AGENDA
PLANNING AND ZONING MEETING
Norwalk City Hall, 705 North Ave
Monday, November 13, 2017
5:45 P.M.

**PLANNING & ZONING COMMISSION
AGENDA STATEMENT**

**PLANNING & ZONING COMMISSION
AGENDA STATEMENT**

Concept 1

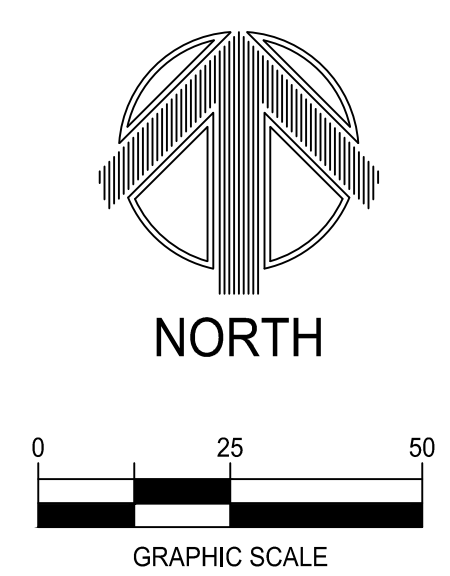
The proposed amendment requests that the undeveloped land at the northeast corner of Lexington Drive and Colonial Circle be allowed to develop as a continuation of the Brownstones at the Legacy. This area is currently in Parcel 2 and identified as Town Center Commercial. The change would remove the land from Parcel 2 and add it into Parcel 12. Parcel 12 is the area designated for the R-3 Brownstones at the Legacy development. This change would allow for a continuation of Brownstone style townhomes that would front to Colonial Circle and Lexington Drive. In addition to the allowed use change, the amendment also proposes a 25' building setback from Lexington Drive right-of-way and 15' building setback from Colonial Circle right-of-way. The typical building setback for R-3 development is 30' from the public right-of-way.

Staff does not have concerns regarding the reduced front setback. Staff opinion is that the 25' setback from Lexington Drive will preserve the current street corridor design while the 15' setback from Colonial Circle will help create a better interaction between the townhomes and the sidewalks and streets in the ROW.

LOT 1 MARKETPLACE AT ECHO VALLEY PLAT 2 GRADING PLAN

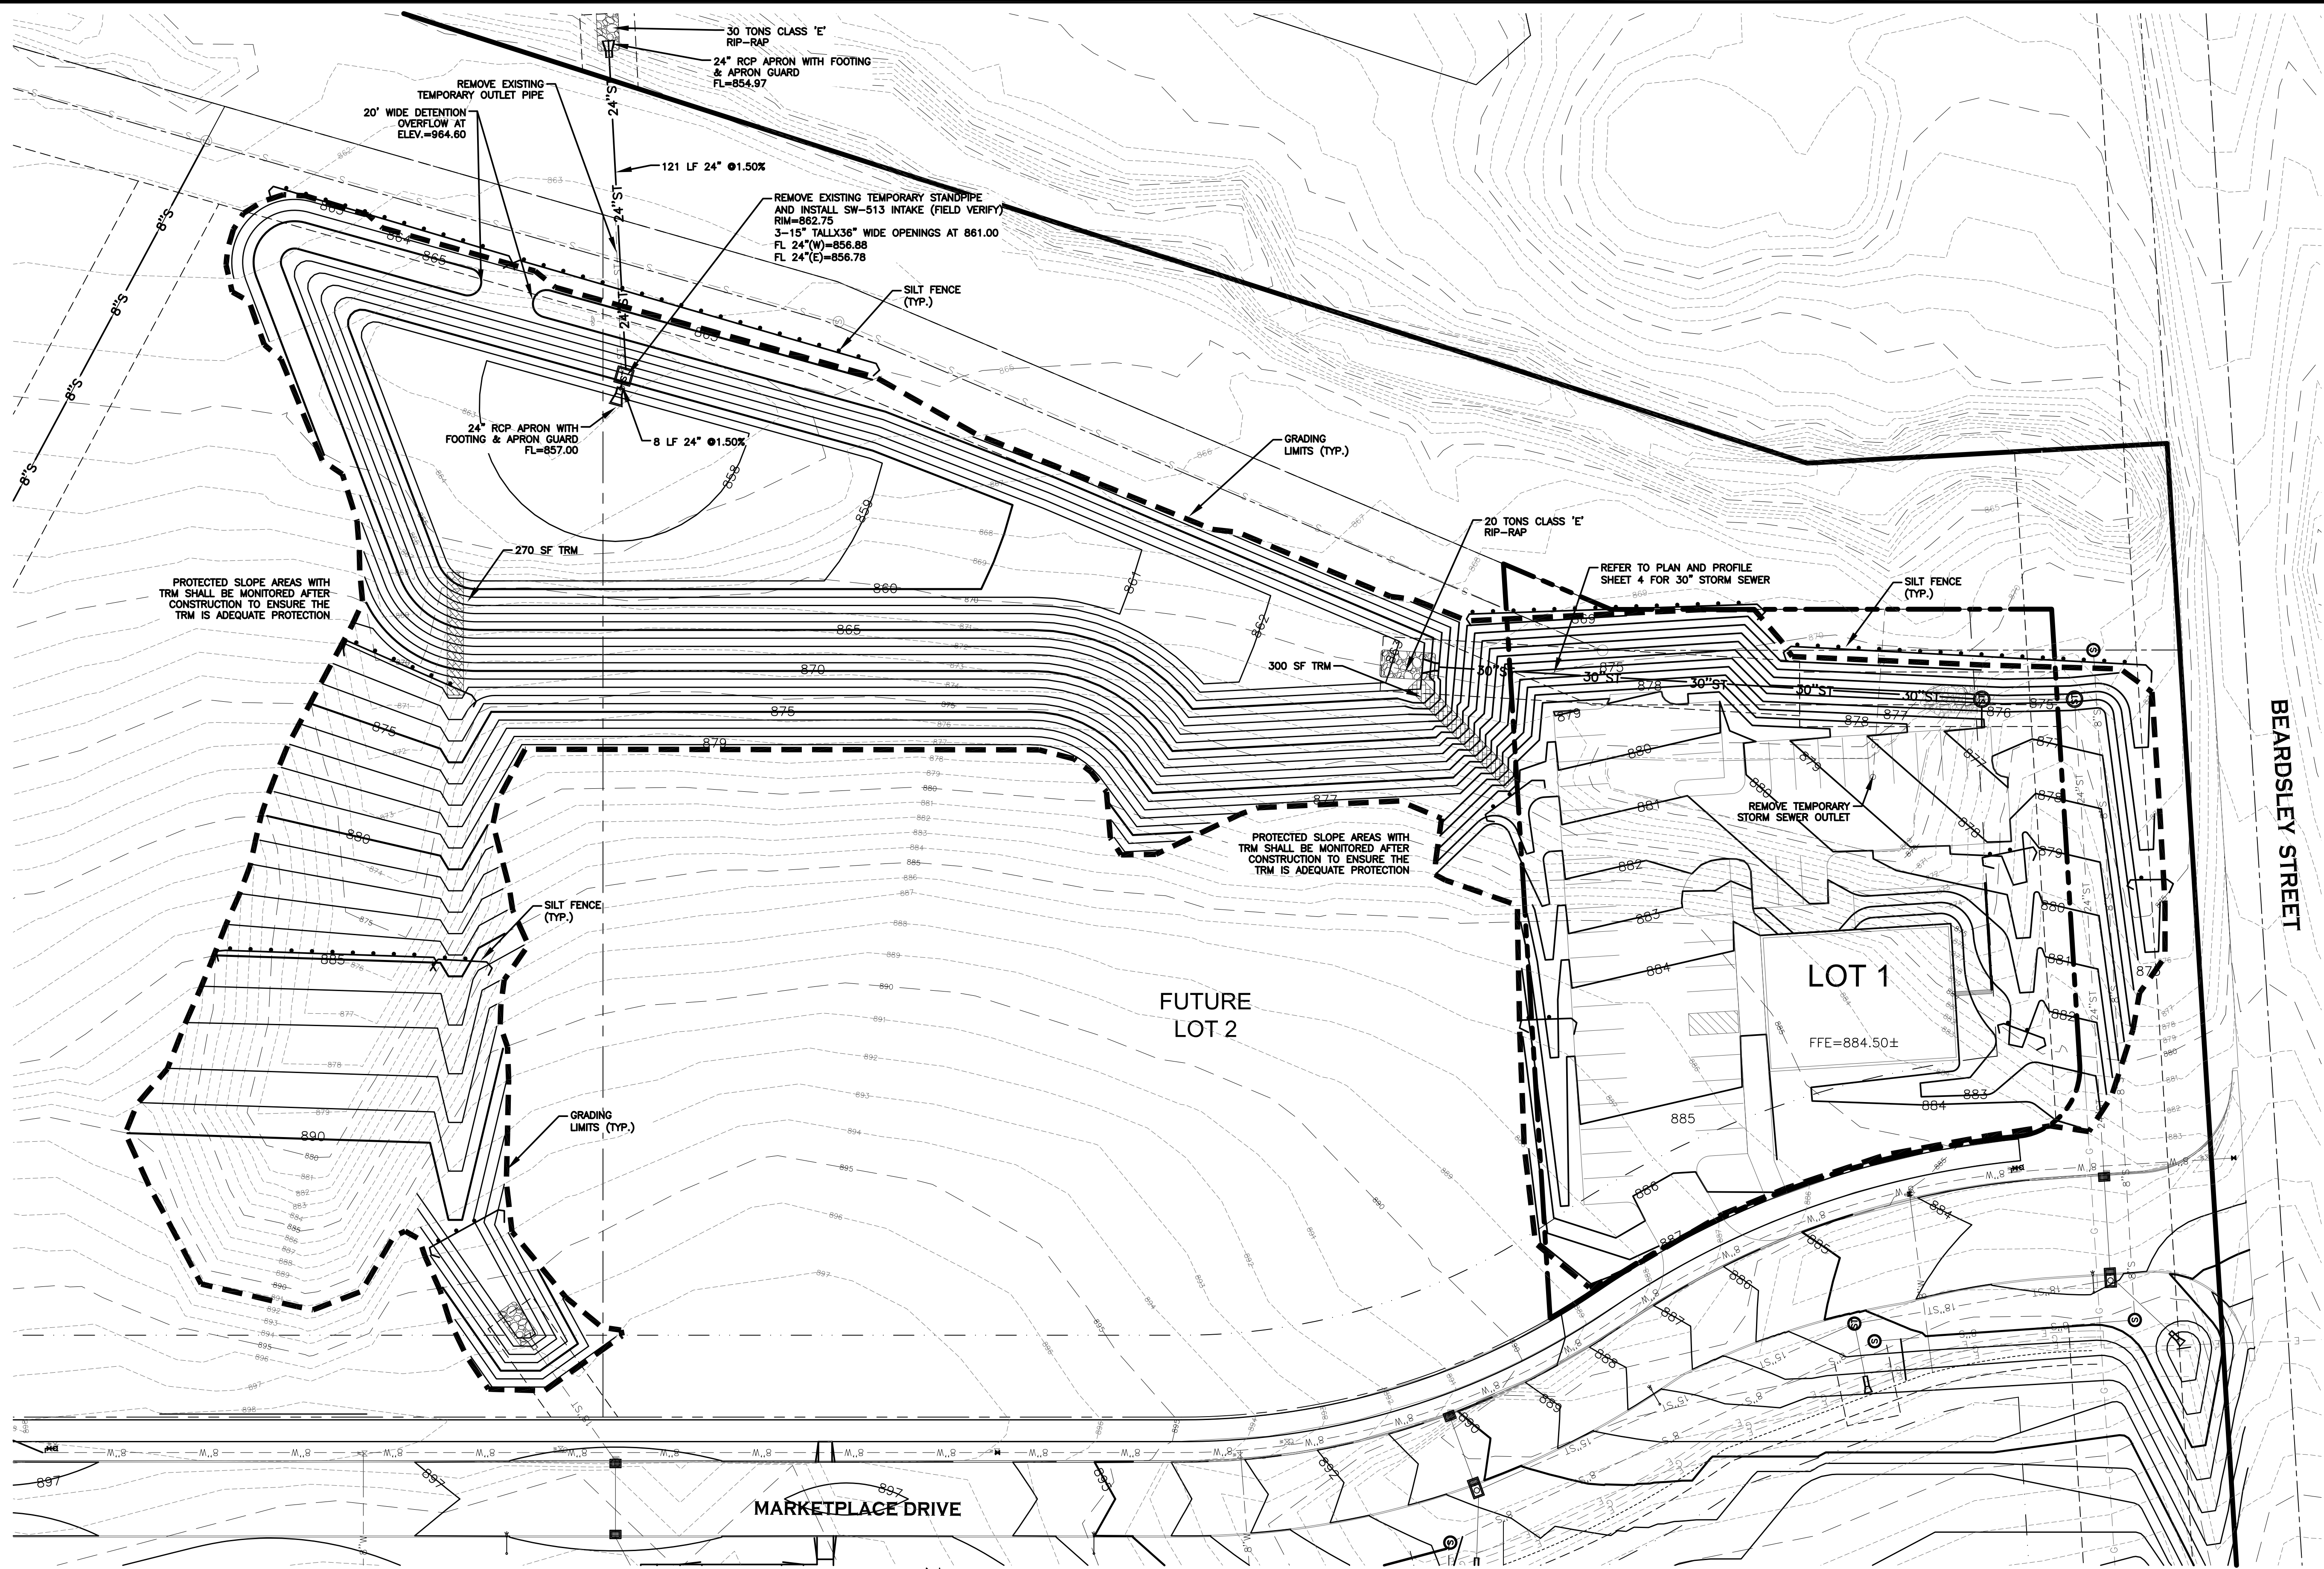
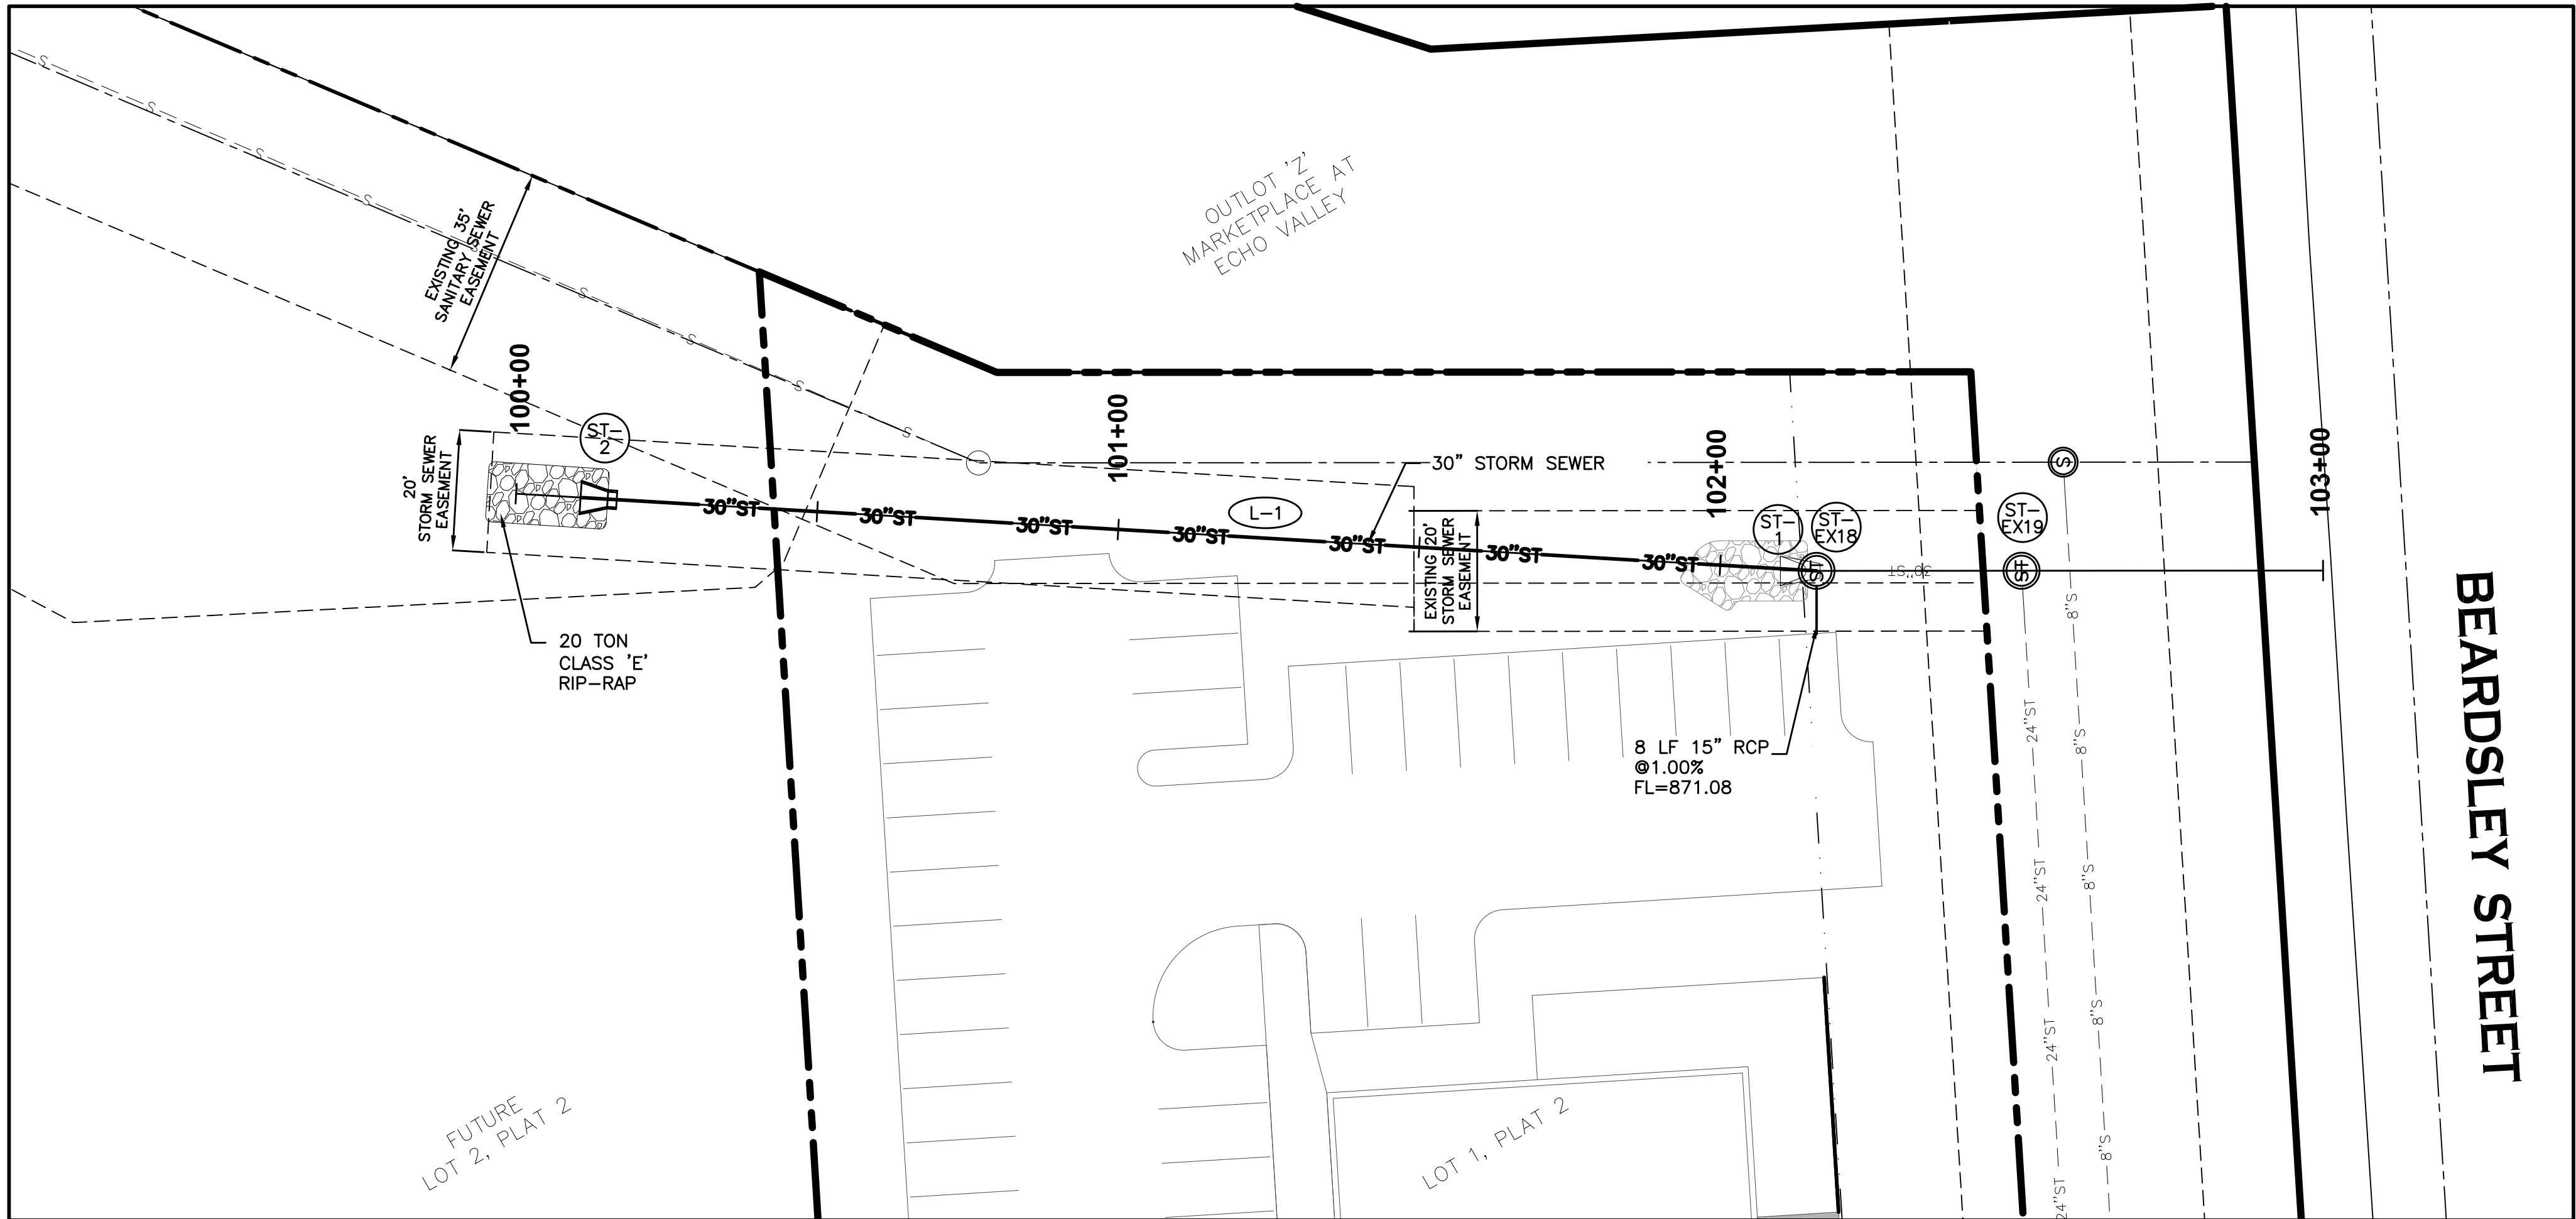
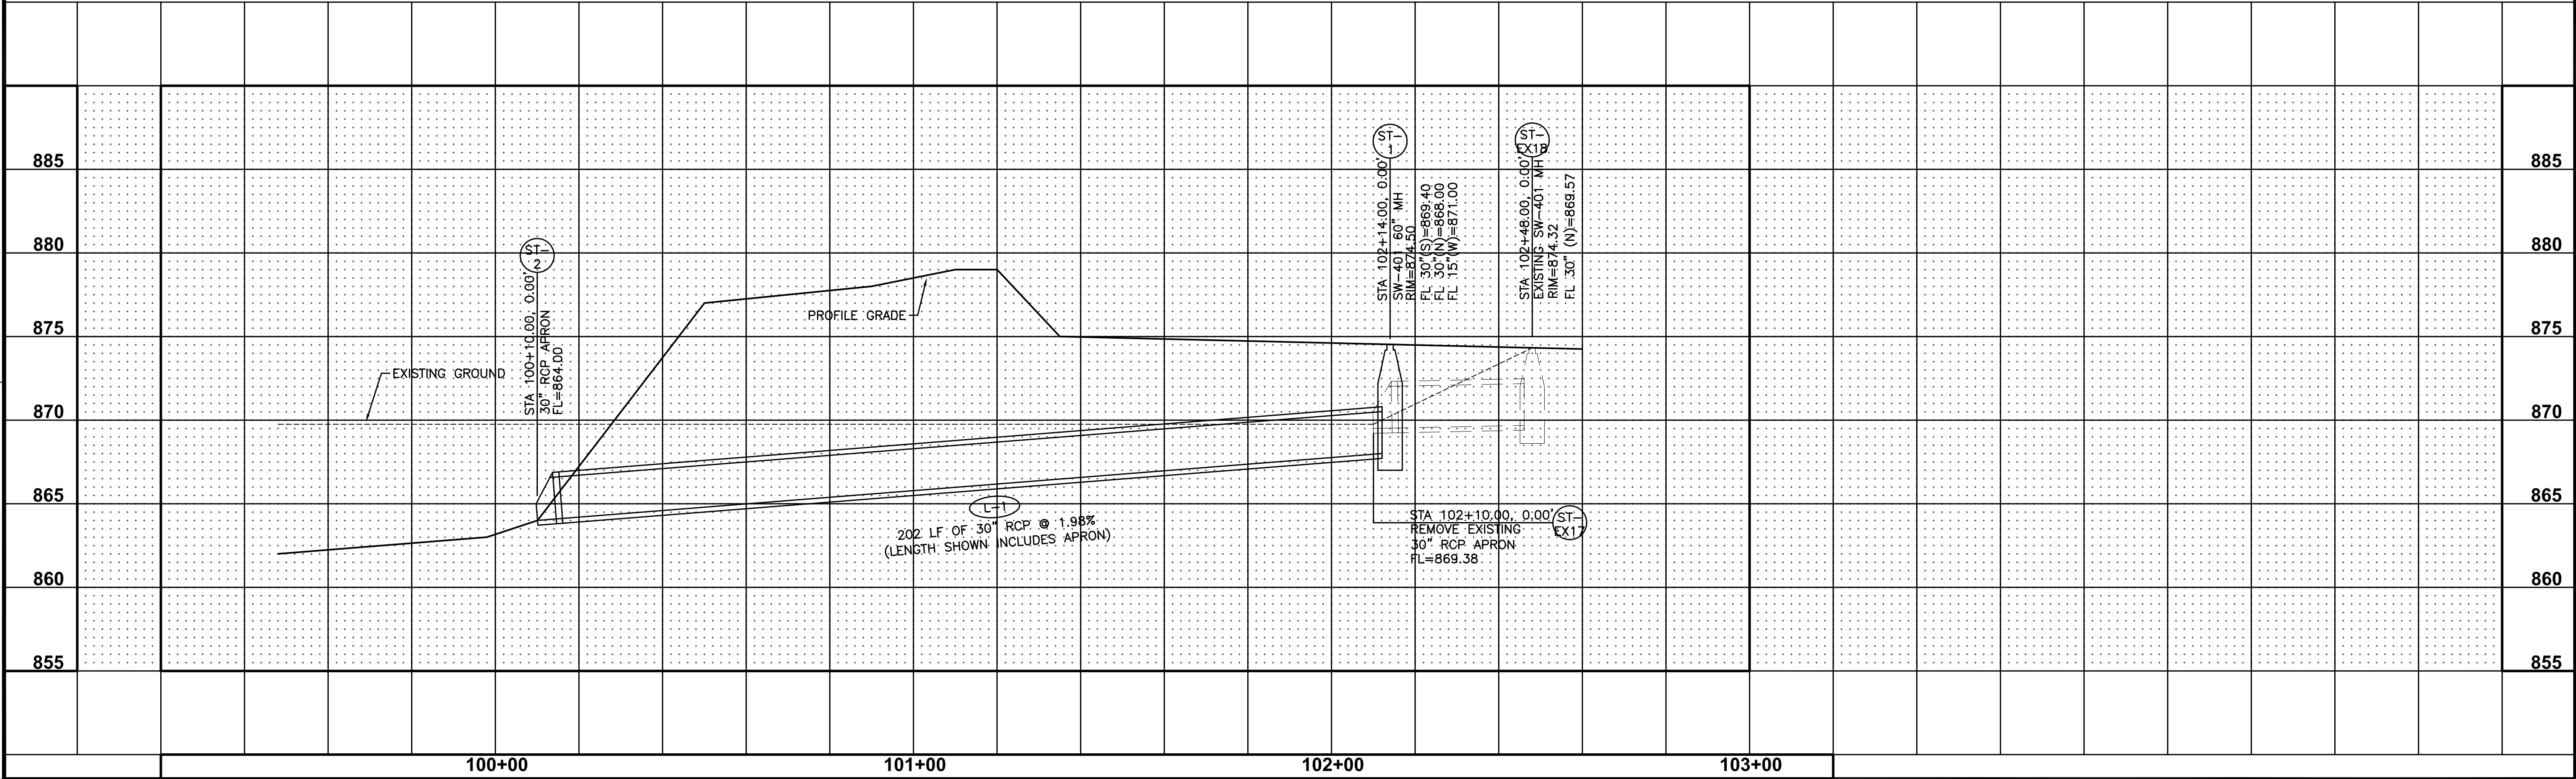
STAFF ANALYSIS: The grading plan shows proposed grading of the permanent detention basin on along the eastern boundary of the Marketplace at Echo Valley development. The City Engineer has reviewed the design of the basin and determined that it meets City requirements for detention. Future development within the area will need to provide storm water calculations to verify that the permanent basin can accommodate storm water runoff.

The grading plan also shows the grading of a pad site on an area labeled as Lot 1 of the Marketplace at Echo Valley Plat 2. City review concurs with the design of the pad site to direct the storm water from the site to the detention basin. Review of the plan focused strictly on the grading of the site. Other site features shown on the grading plan were conceptual in nature and not part of any approval of the grading plan. Future development of Lot 1 will include platting and site plan review of all aspects of the site, including potential grade changes based on the criteria of a future user.

The staff recommends approval of the grading plan noting the following:

- That the site grading will follow all City code regulations.
- That all proper storm water controls shall be installed and in place during all grading operations.
- That additional development review, recommendation by Commission, and approval by Council will be required for the future development of the area.
